Source : NTT, KDD, NEC, and FUJITSU  
Title : PSEUDOSYNC CODE

Fig. 1 Switching by MCU

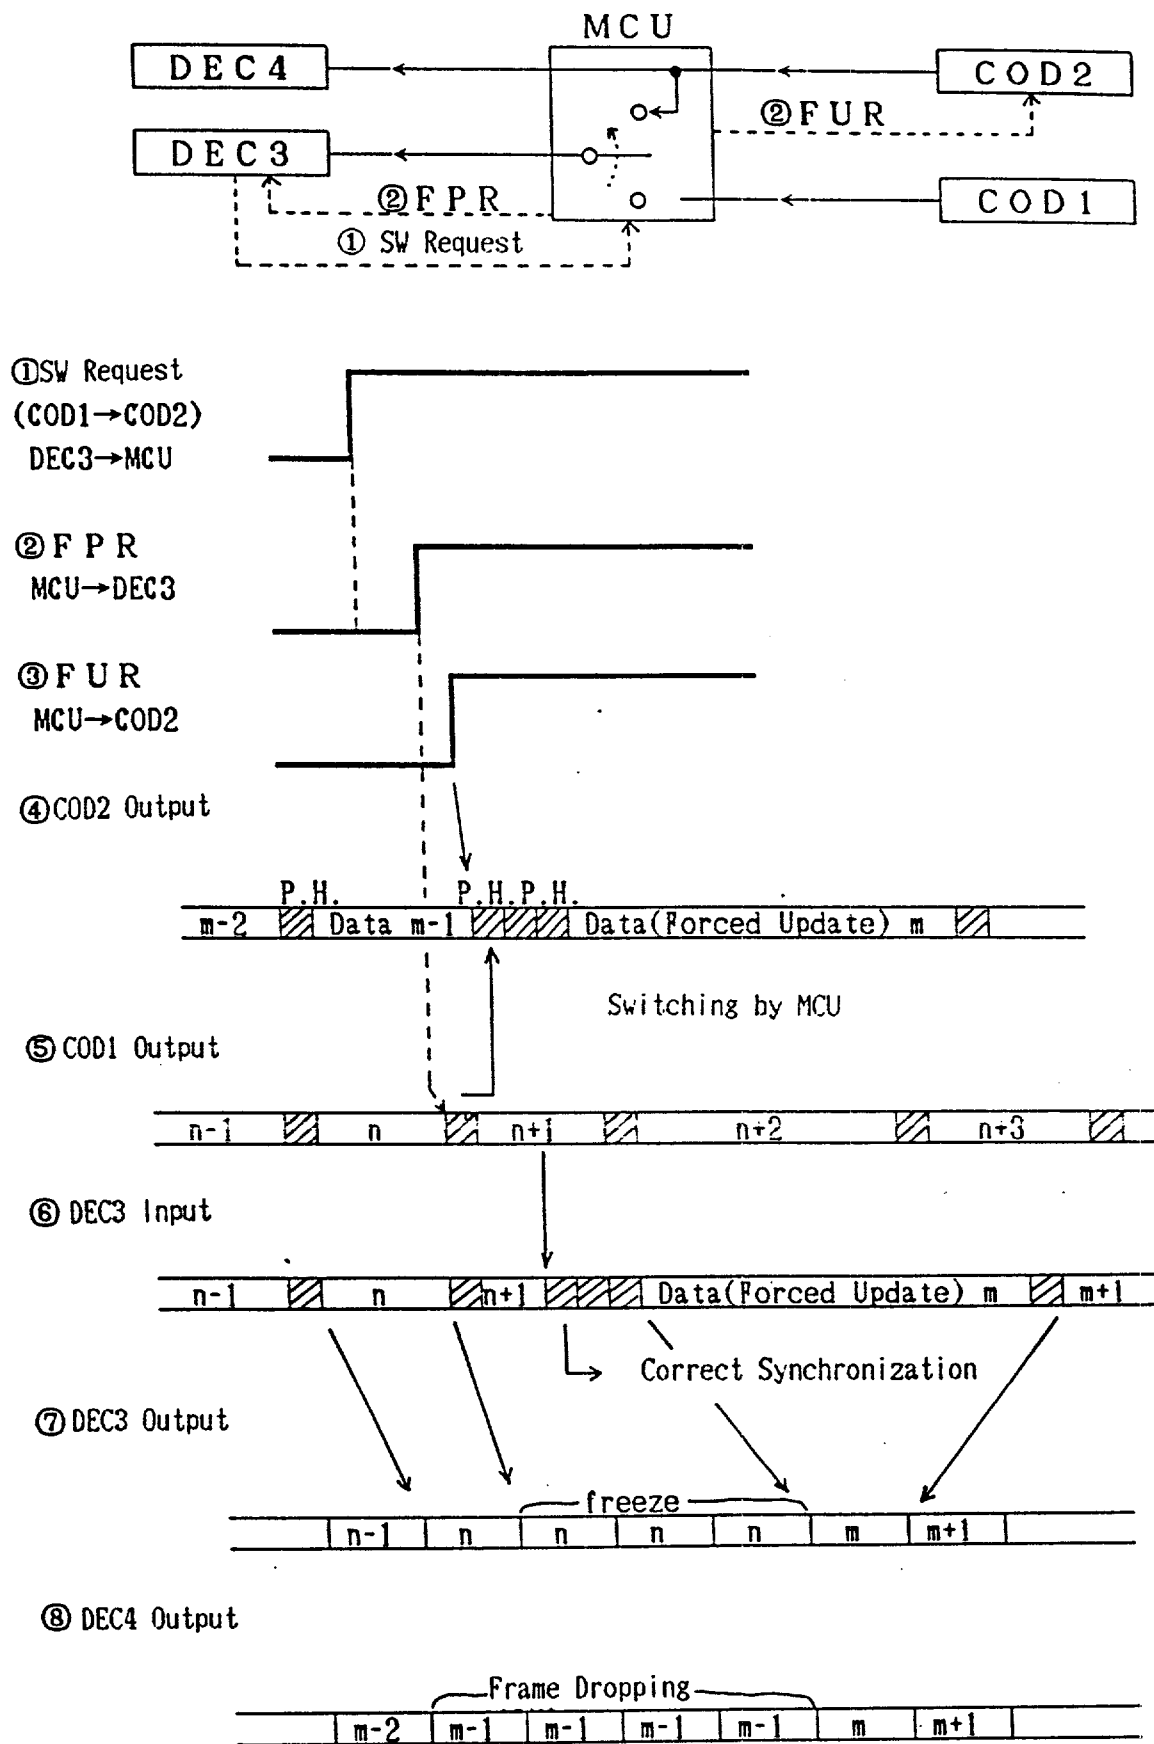
If we assume that video frame is recovered whenever a PSC is found, Picture Header preceding the Forced Update frame data should be detected without failure in switched multipoint connection. (cf. Fig. 1) We also assume here that once a PSC or GBSC is detected, detection circuit is switched off for predetermined intervals to cope with that PSC or GBSC is not unique.

If change-over to a new location is made at MCU between PSC and PEI or PEI and Extra Information bits just preceding the Intra-mode frame, the new Picture Header would not be found due to protection capability i.e. skipping of PSC detection during 19 bits after PSC or  $(3+m) \times 8$  bits after PEI.

Following points are left for further consideration.

- Whether or not addition of the frame dropping above is automatically evoked at the transmitter, when emptying the transmission buffer as specified with respect to FUR.

- Whether or not detection of the first PSC for Intra-mode is ensured by designing appropriate time differences for FPR, switching, and FUR at MCU.

In order to avoid this difficulty, frame dropping should be at first evoked possibly with some amount of bits enough to prevent the protection capability from affecting the next PSC detection.
